CONSTRUCTION DOCUMENTS
HILLROYS
for
Pagan Hill & Rob Roys

1403
SHEET TITLE
SITE & ROOF
PLAN,
SETBACKS

FILE NO.: AME2017 0008 and 0009

SECTION @ BAY WINDOW V.2

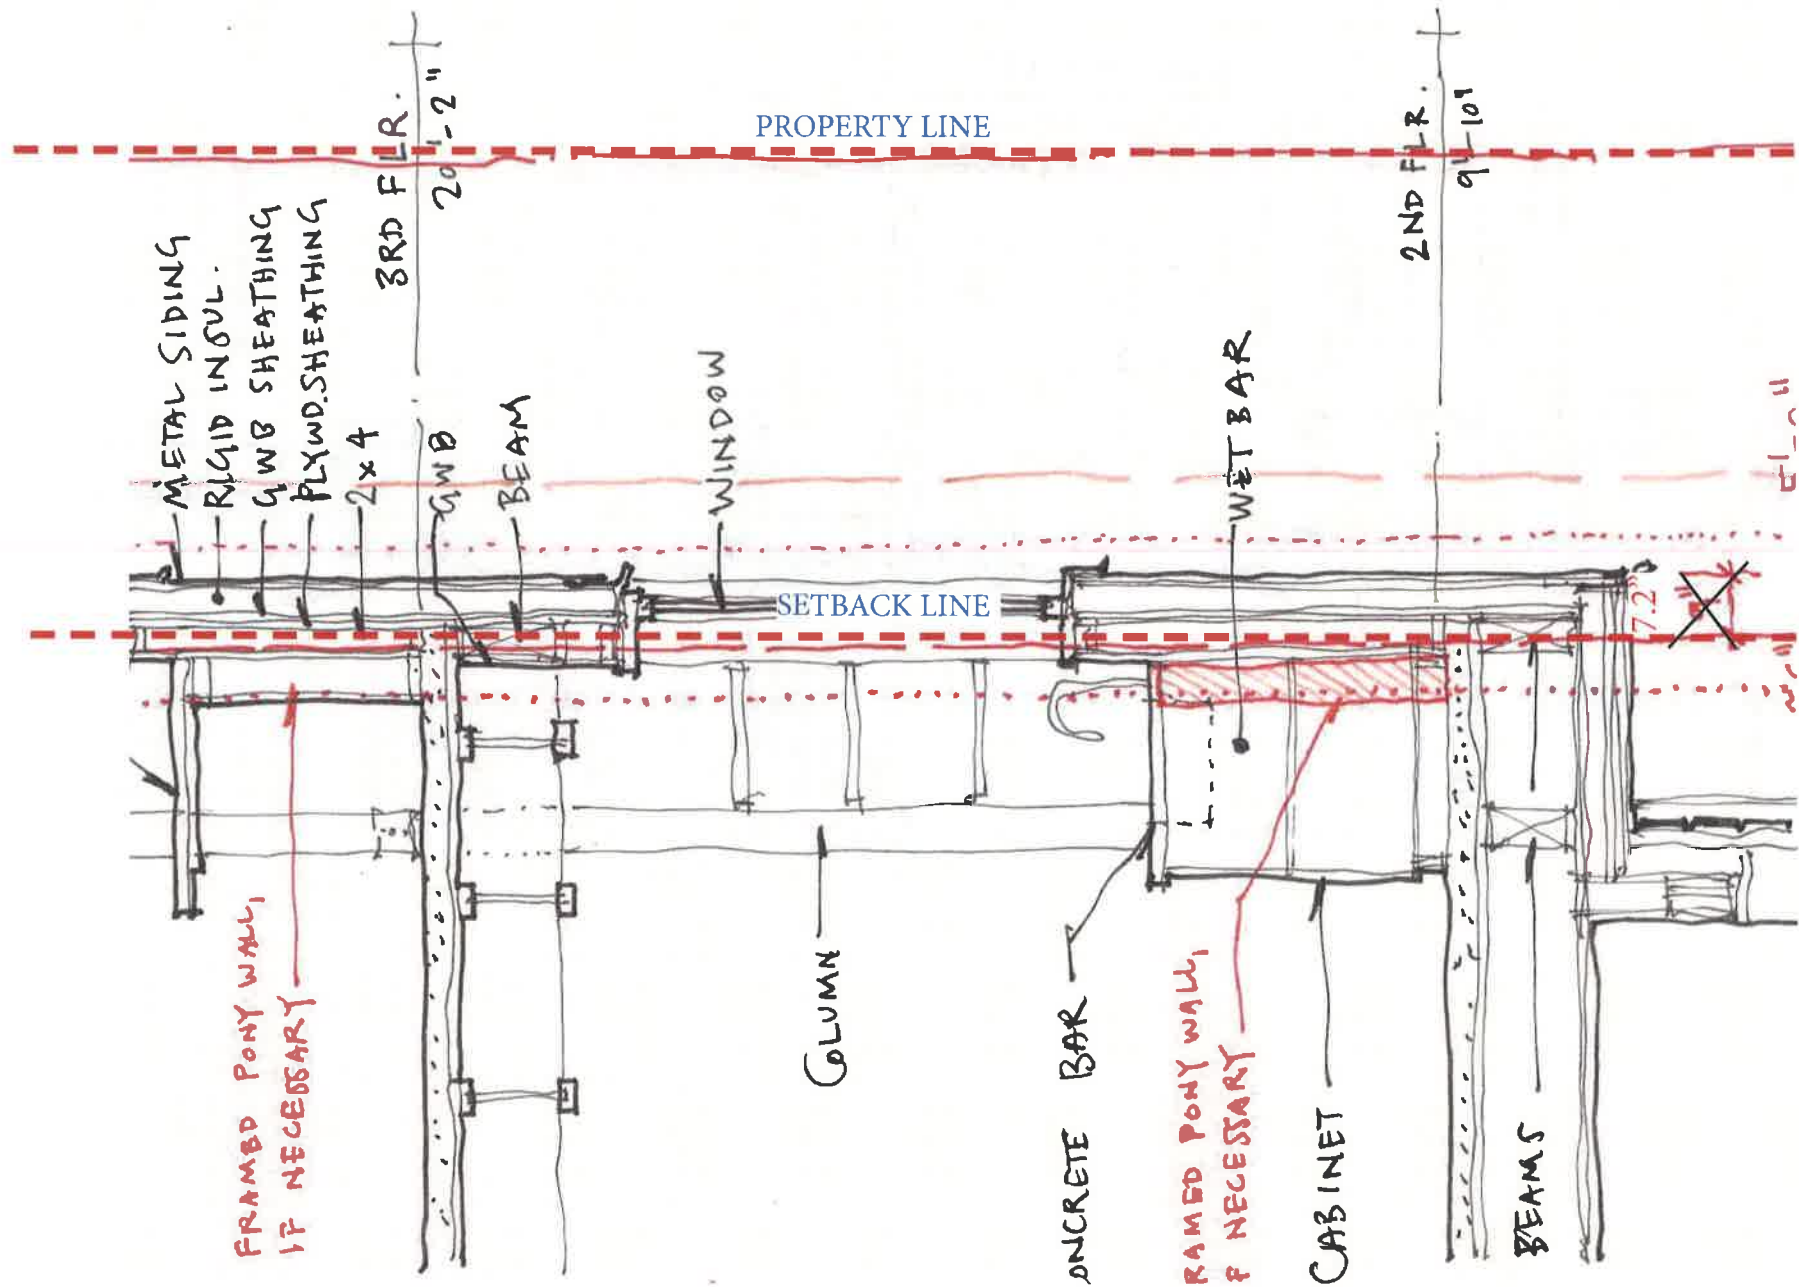
NOTE: * EXT. WALLS WERE CONSTRUCTED DIFFERENTLY THAN DESIGN DWGS. CONTRACTOR ELIMINATED SEVERAL COMPONENTS: INCL. PANELS, FURRING, WATERPROOF MEMBRANE, & BUCKENED CEDAR/FURRING ON OPPOSITE SIDE.

Character of Neighborhood?

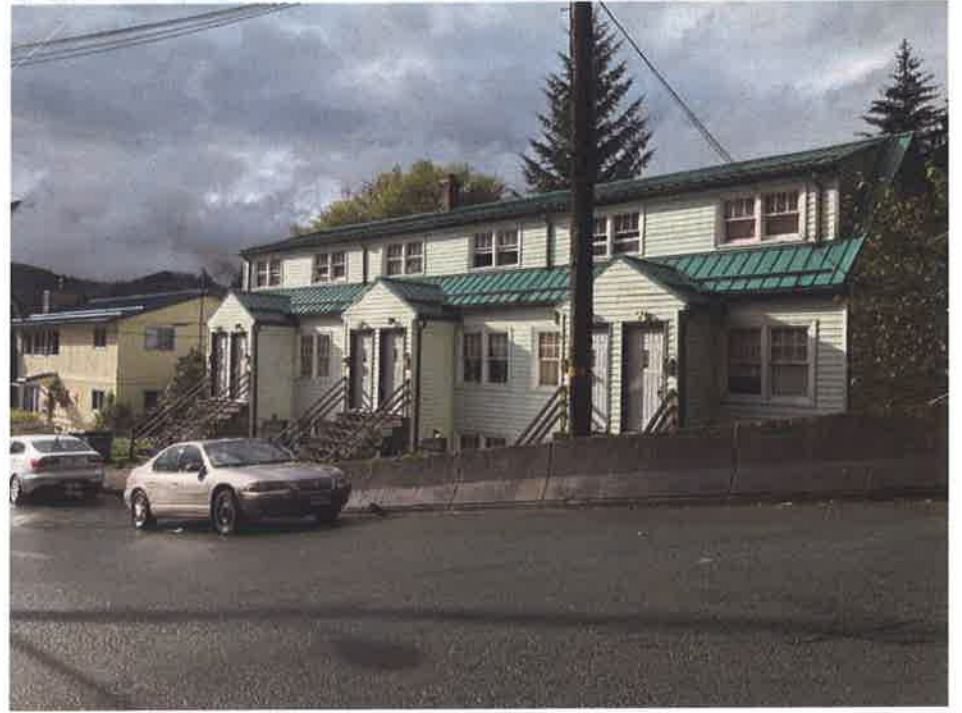
There are no design standards for this neighborhood.

Unlike Juneau Downtown Historic District,
Casey-Shattuck Neighborhood
is not a designated Historic District

There are no design standards for this neighborhood

Neighboring single-family residence: 3 story
